Fiat Scudo - Potência insuficiente do ar condicionado | HELLA

Scudo 1,6D Multijet 90

Ano de fabrico: de 2007 até VIN 84160387

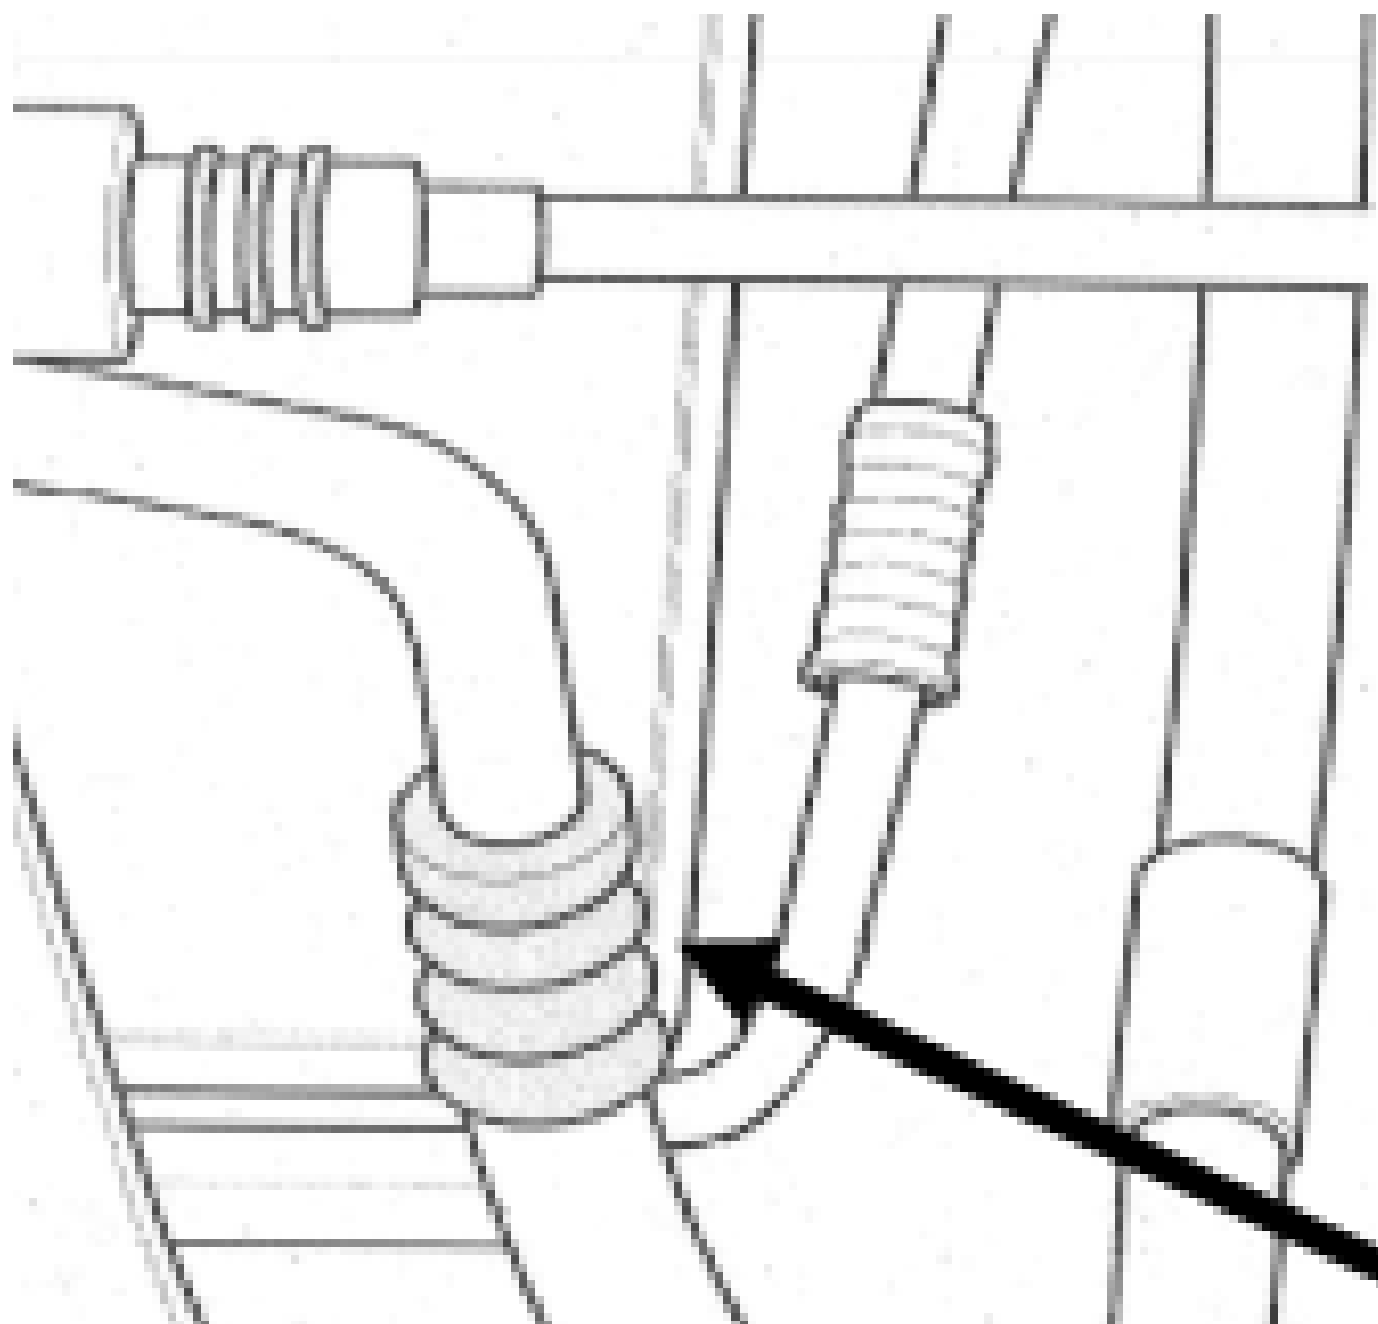
Se nos veículos supracitados for detetada uma potência insuficiente do ar condicionado ou uma perda do líquido refrigerante, uma possível causa pode ser uma fuga na tubagem do líquido refrigerante entre o condensador e o compressor.

Verificar se a conexão do líquido refrigerante é do tipo correto e eventualmente substituir. (Ver figuras)

Tipo antigo

O fabricante automóvel dispõe de um tipo modificado: [Peças Sobressalentes (PS)]

- 1 unidade: tubagem do líquido refrigerante :(PS):. 140142280

2 unidades: O-Ring: (PS):. 9645950980

-Novo tipo -
